1 Replacing a Single Phase Smart Drive

If you are replacing a Single Phase Smart Drive with a Three Phase Smart Drive, there may be both wiring as well as software changes required. This Instruction Sheet outlines these requirements.

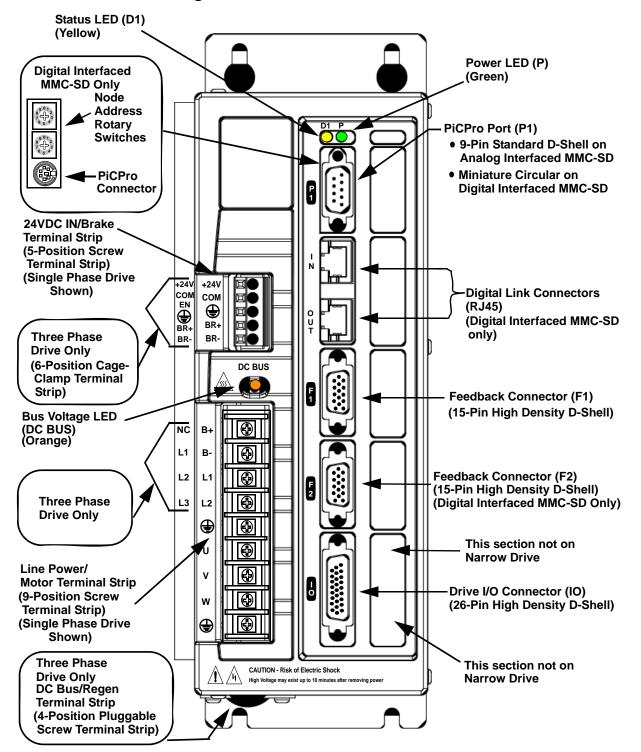
The right side of both the single and Three Phase Drives, containing the "D1" and "P" LED indicators, as well as the PiCPro, Digital Link, F1/F2 Feedback, and Drive I/O Connectors, are identical. Refer to Figure 1-1 on page 4

The left side of the Single Phase and the Three Phase Drive, as shown in Figure 1-1 on page 4, differ as follows:

- Single Phase drive connectors
 - 5-pin DC Power and Brake connector
 - 9-pin AC Power, Motor, and DC Bus connector
- Three Phase drive connectors
 - 6-pin DC Power, Brake, and Safe-off connector
 - 9-pin AC Power and Motor connector
 - 4-pin DC Bus and Regen Resistor connector (located on the bottom of the drive)

The Three Phase Drive has an extra terminal labeled "EN" on the DC Power Connector located on the front of the Drive. This terminal must be powered by a nominal 24VDC in order for the drive to operate. The Three Phase Drive comes with a jumper installed between "EN" and the "+24V" DC Power input. Leave this jumper installed, and connect the remaining five terminals (labeled +24V, COM, Br+, Br-, Chassis Ground) from the Single Phase Drive being replaced to the indenticallymarked five terminals on the Three Phase drive.

The Three Phase Drive has two terminals, labeled "L3" and "NC", on the AC Power Connector located on the front of the Drive. Nothing will be connected to these terminals. The Single Phase Drive has two terminals labeled "B+" and "B-" on the AC Power Connector located on the front of the Drive. The wires going to these terminals will be connected to the Three Phase Drive's BUS/REGEN terminal as described Section 1.3.3 below.

The Three Phase Drive contains a 4-pin Bus/Regen connector located on the bottom of the drive. Nothing will be connected to the terminals labeled "R+" and "R-". If there are wires on the Single Phase Drive's AC Power Connector B+ or B- terminals, move these wires to the identically-marked Three Phase Drive's Bus/Regen connector's B+ and B- terminals.

Connect the remaining seven terminals (labeled L1, L2, U, V, W, and two Chassis Grounds) from the Single Phase Drive being replaced to the indentically-marked seven terminals on the Three Phase Drive.
